Virgil C. Summer Nuclear Station (VCSNS) Units 2 and 3  
Combined License Nos. NPF-93 and NPF-94  
Docket Nos. 52-027 & 52-028

Subject: LAR 13-08 Request for License Amendment: Module Obstructions and  
Details

License Amendment Request (LAR 13-08): Module Obstructions and Details

**Proposed Changes to Licensing Basis Documents  
(LAR 13-08)**

**Tier 2, Figure 3.8.3-8 (Sheet 1 of 3) (Partial)**  
**“Structural Modules – Typical Design Details”**

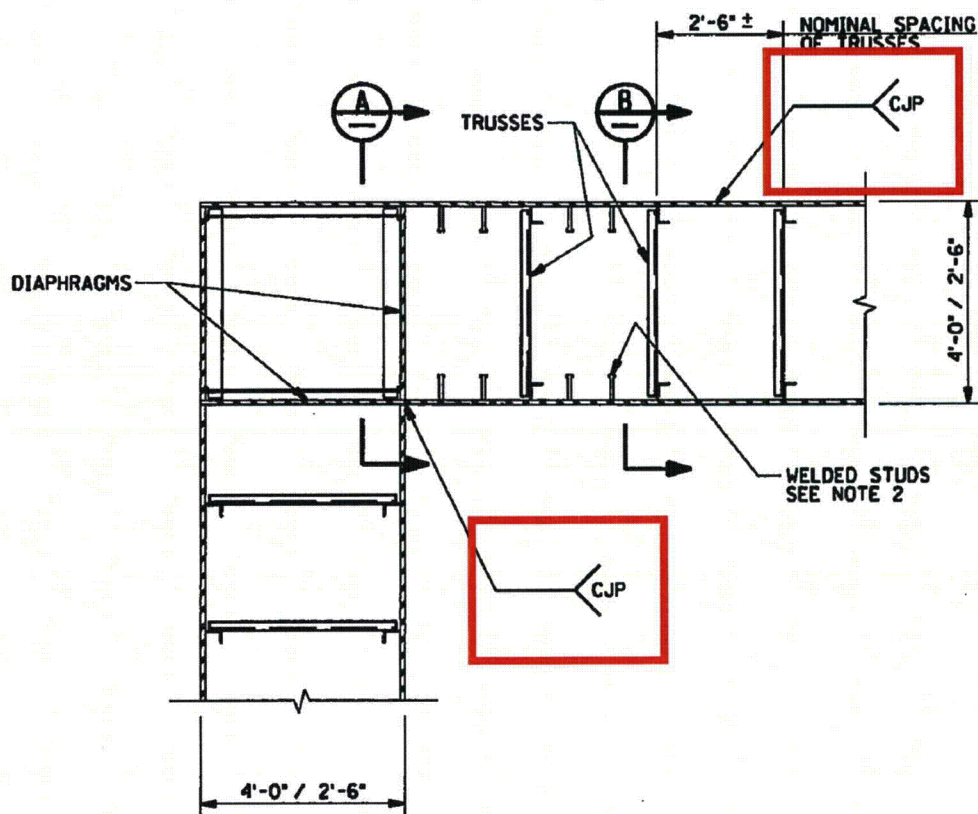
Revise Figure 3.8.3-8 (Sheet 1 of 3) as described and shown below.

In the Detail 1 Plan View, revise the weld symbols to signify Complete Joint Penetration Welds.

- UFSAR Figure 3.8.3-8 Sheet 1, "Structural Modules – Typical Design Details," the weld symbol for faceplate welds is changed to show a complete joint penetration weld.

The welds between module faceplates in subassemblies and completed modules are required to be complete joint penetration welds. Any weld that provides complete joint penetration including bevel and V-groove welds and that satisfies design requirements and other regulatory commitments is acceptable. Figure 3.8.3-8 Sheet 1 uses the weld symbol for square groove weld for the welding together of faceplates. The square groove weld is one type of complete joint penetration weld. The designation of a square groove weld does not reflect the preferred weld design for module fabrication.

Module faceplates are required by the design criteria discussed in the UFSAR to be joined with complete joint penetration welds to provide that the capacity of the plates is developed across the weld seam. A properly welded complete joint penetration provides this capacity. A square groove weld is not the only means to achieve a complete joint penetration weld. Other groove welds such as a bevel or V-groove weld also provide a complete joint penetration weld and with greater facility than a square groove weld.
